**BAYOU BIENVENUE
CONTROL STRUCTURE**

PERIODIC INSPECTION REPORT NO. 4

SUBJECT: Lake Pontchartrain, Louisiana and Vicinity, Chalmette Area
Plan; Bayou Bienvenue Control Structure, Periodic Inspection
Inspection No. 4, March 1985

1. The enclosed periodic inspection report is approved subject to the following comments:

SOUTHEAST WING WALL

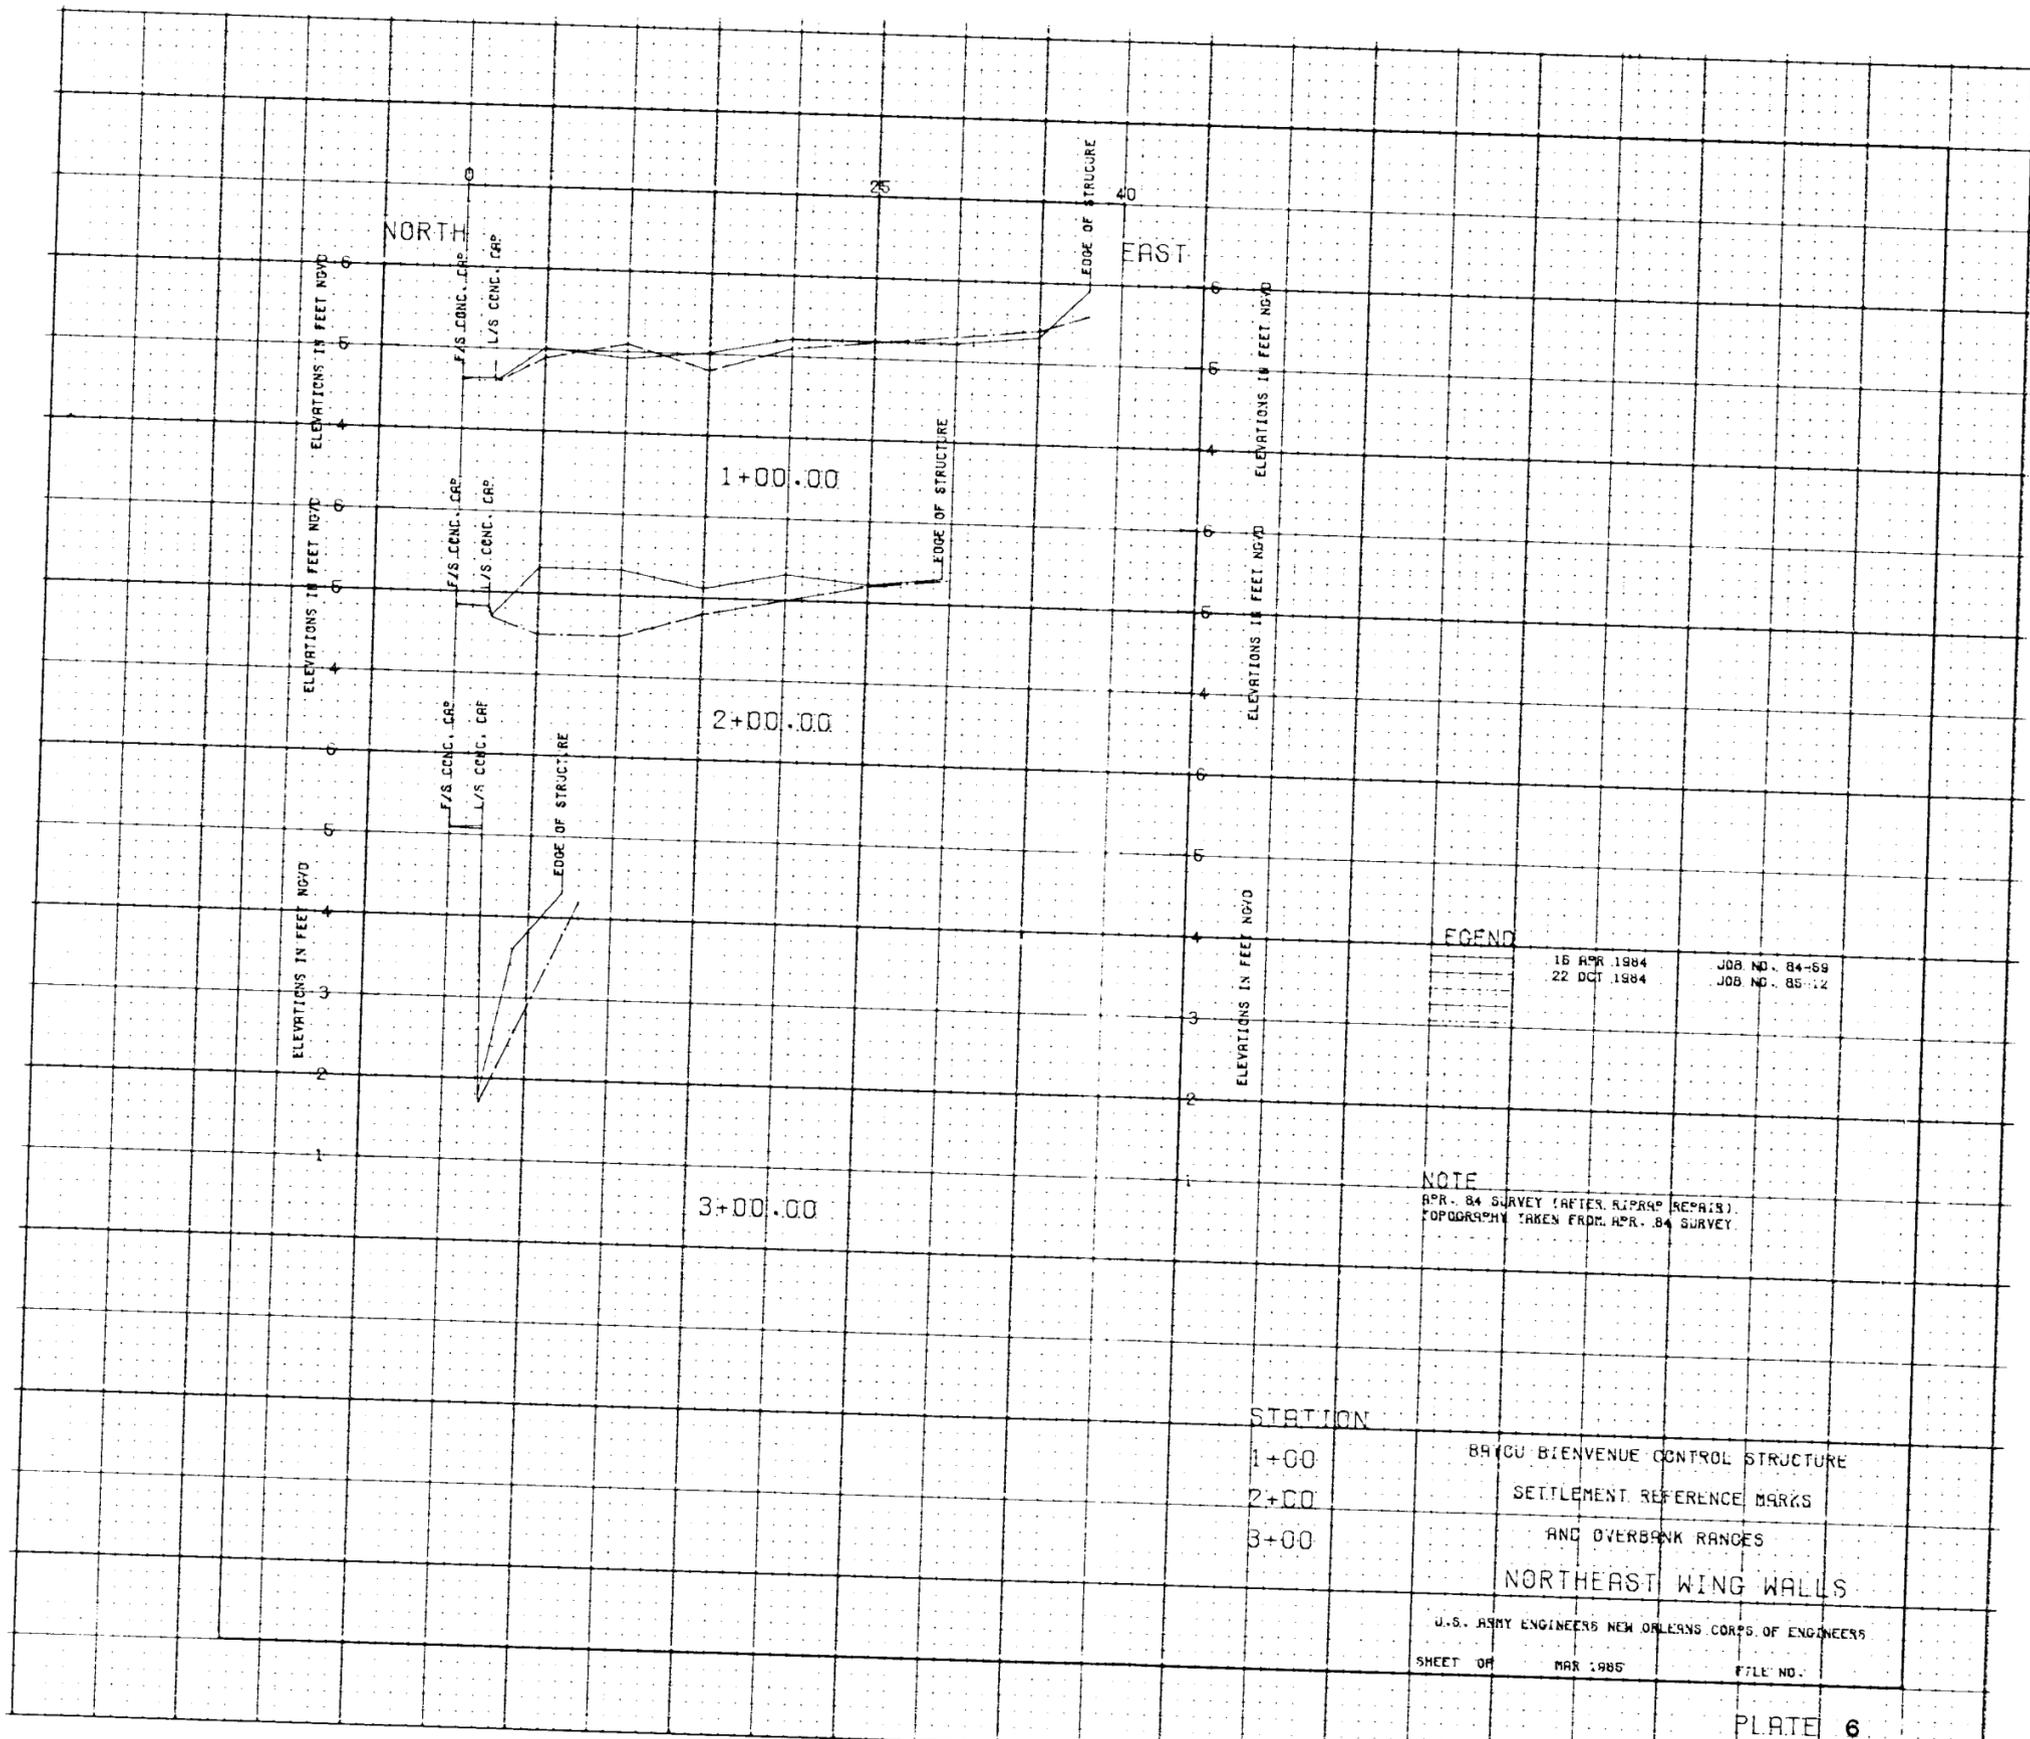
(c) Overbank Range Survey. The overbank range surveys, dated 22 Oct 84, indicate sinkholes or loss of material behind the northeast and northwest wingwalls at range 3+00. The surveys for the south wingwalls indicate very little settlement or loss of material behind the

walls. These sinkholes will be investigated during the upcoming inspection. Plates 6 through 9.

3. Erosion and Sinkholes. Sinkholes approximately 3 feet in diameter by 3 feet deep were observed at station 3+00 behind the northwest and northeast wingwalls. It seems the holes were caused by material being washed out past the rubber waterstop between the rubber waterstop between the structure and wingwalls. Also observed during the inspection was erosion on the ends of all the wingwalls.

e. Sinkholes and voids behind the wingwalls will be backfilled.
